Project Name & Address  
**VOLKSWAGEN HATFIELD**  
COMET WAY, HATFIELD, AL10 9TF  
Residential Development  
Drawing Title  
AMENDED FLOOR PLANS- THIRD FLOOR

Drawn By	F.P	Date	03.10.2022
Checked By	F.J	Date	13.10.2022
Approved By	B.R	Date	14.10.2022
Drawing Number	<b>HAT-RDB-XX-03-DR-A-NMA-0203</b>		
Sheet No.	01	Scale	1:100
Orig. Sheet Size	@A0	Rev.	R02

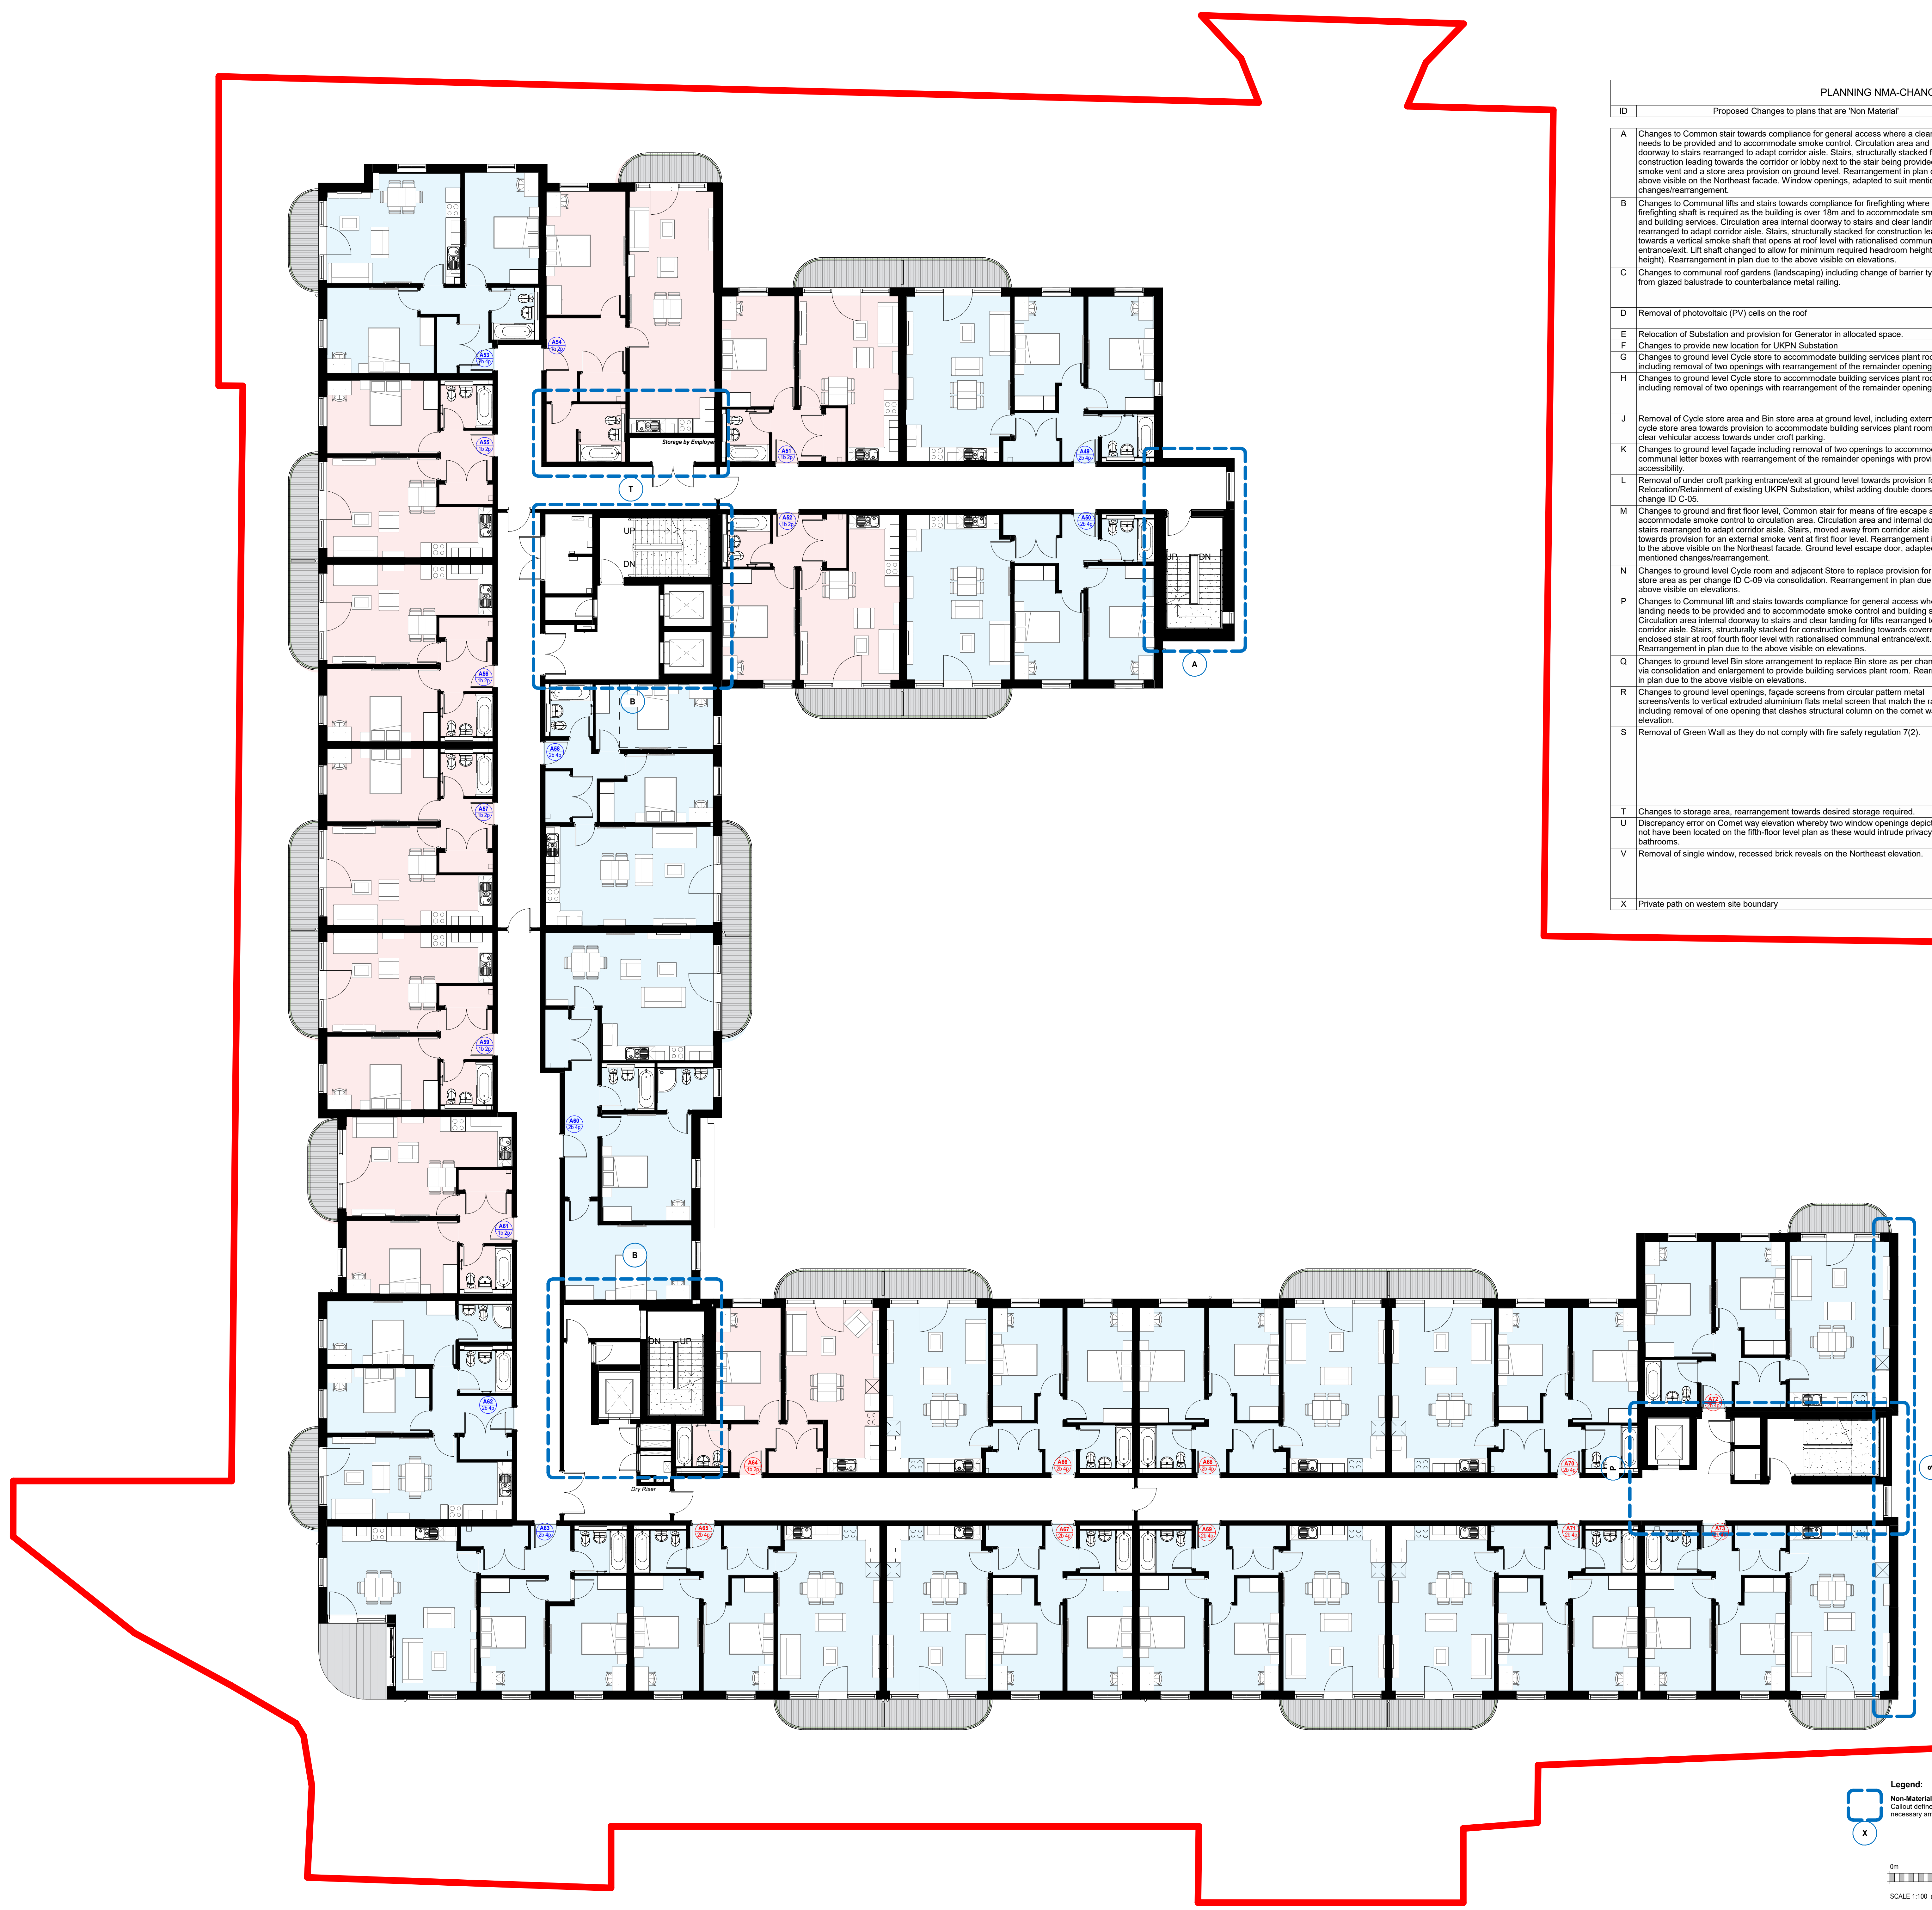
PLANNING NMA-CHANGE LIST		
ID	Proposed Changes to plans that are 'Non Material'	Reason for 'Amendment'
A	Changes to Common stair towards compliance for general access where a clear landing needs to be provided and to accommodate smoke control. Circulation area and internal doorway to stairs rearranged to adapt corridor aisle. Stairs, structurally stacked for construction leading towards the corridor or lobby next to the stair being provided with a smoke vent and a store area provision on ground level. Rearrangement in plan due to the above visible on the Northeast facade. Window openings, adapted to suit mentioned changes/rearrangement.	Compliance towards Building Regulations, Part-K-Protection from falling, collision and impact and Part-B-Fire safety
B	Changes to Communal lifts and stairs towards compliance for firefighting where a firefighting shaft is required as the building is over 18m and to accommodate smoke control and building services. Circulation area internal doorway to stairs and clear landing for lifts rearranged to adapt corridor aisle. Stairs, structurally stacked for construction leading towards a vertical smoke shaft that opens at roof level with rationalised communal entrance/exit. Lift shaft changed to allow for minimum required headroom height (Overhead height). Rearrangement in plan due to the above visible on elevations.	Compliance towards Building Regulations, Part-K-Protection from falling, collision and impact, Part-B-Fire safety, and Provision for minimum required headroom height as per standards EN81-20

C	Changes to communal roof gardens (landscaping) including change of barrier type (railing) from glazed balustrade to counterbalance metal railing.	To contribute positively towards biodiversity via balance of soft and hard landscaping schemes including provisions for bird and bat boxes, whilst maintaining overall uniformity for railing type.
D	Removal of photovoltaic (PV) cells on the roof	PV was not required as Part L requirement was met using Exhaust Air Heat Pumps.
E	Relocation of Substation and provision for Generator in allocated space.	Provision for separate secluded area for generator
F	Changes to provide new location for UKPN Substation	Provision for future relocation for UKPN Substation
G	Changes to ground level Cycle store to accommodate building services plant rooms including removal of two openings with rearrangement of the remainder openings.	Provision towards Building Services, Secondary LV switch room and Comms room.

H	Changes to ground level Cycle store to accommodate building services plant rooms including removal of two openings with rearrangement of the remainder openings.	Provision towards secure access and splitting into 4 small bin stores to comply with recent updates of having maximum 8 large (1100lrs) receptacles within.
J	Removal of Cycle store area and Bin store area at ground level, including external door in cycle store area towards provision to accommodate building services plant room including clear vehicular access towards undercroft parking.	Provision towards Building Services, Primary LV switch room and vehicular access towards undercroft parking.
K	Changes to ground level facade including removal of two openings to accommodate communal letter boxes with rearrangement of the remainder openings with provision for accessibility.	Provision towards communal letter boxes
L	Removal of undercroft parking entrance/exit at ground level towards provision for Relocation/Retention of existing UKPN Substation, whilst adding double doors as per change ID C-05.	Provision towards single point of entry/exit for undercroft parking and towards relocation/retention of existing UKPN Substation mentioned in change ID-E.

M	Changes to ground and first floor level, Common stair for means of fire escape and to accommodate smoke control to circulation area. Circulation area and internal doorway to stairs rearranged to adapt corridor aisle. Stairs, moved away from corridor aisle leading towards provision for an external smoke vent at first floor level. Rearrangement in plan due to the above visible on the Northeast facade. Ground level escape door, adapted to suit mentioned changes/rearrangement.	Compliance towards Building Regulations, Part-B-Fire safety.
N	Changes to ground level Cycle room and adjacent Store to replace provision for Cycle store area as per change ID C-09 via consolidation. Rearrangement in plan due to the above visible on elevations.	Provision towards replacement of removed cycle store mentioned in change ID-J.
P	Changes to Communal lift and stairs towards compliance for general access where a clear landing needs to be provided and to accommodate smoke control and building services. Circulation area internal doorway to stairs and clear landing for lifts rearranged to adapt corridor aisle. Stairs, structurally stacked for construction leading towards covered and enclosed stair at roof fourth floor level with rationalised communal entrance/exit. Rearrangement in plan due to the above visible on elevations.	Compliance towards Building Regulations, Part-K-Protection from falling, collision and impact, Part-B-Fire safety and Provision for stair enclosed/walkway that is directly covered.

Q	Changes to ground level Bin store arrangement to replace Bin store as per change ID C-09 via consolidation and enlargement to provide building services plant room. Rearrangement in plan due to the above visible on elevations.	Provision towards replacement of removed Bin store mentioned in change ID-J and provision for BCW Tank room
R	Changes to ground level openings, facade screens from circular pattern metal screens/vents to vertical extruded aluminium flats metal screen that match the railing type, including removal of one opening that clashes structural column on the corner way elevation.	To maintaining overall architectural uniformity and structural framing.
S	Removal of Green Wall as they do not comply with fire safety regulation 7(2).	Regulation 7(2), requires all residential blocks with top-storey heights over 18m to have all materials which become part of an external wall or specified attachment (e.g., balconies) to achieve class A2-s1, d0 or class A1, except for materials which are exempt as per regulation 7(3). Additionally, membranes used as part of external wall construction above ground should achieve a minimum of class B-s3, d0.

T	Changes to storage area, rearrangement towards desired storage required.	Provision towards desired storage required.
U	Discrepancy error on Comet way elevation whereby two window openings depicted would not have been located on the fifth-floor level plan as these would intrude privacy for the bathrooms.	Discrepancy error
V	Removal of single window, recessed brick reveals on the Northeast elevation.	The recessed brick reveals is towards the left of a single pane window for levels 1-4, whilst it changes to a double pane for level 5. To maintain architectural uniformity, we have detailed a constant double pane window for all levels.
X	Private path on western site boundary	For Façade maintenance MEWP access.
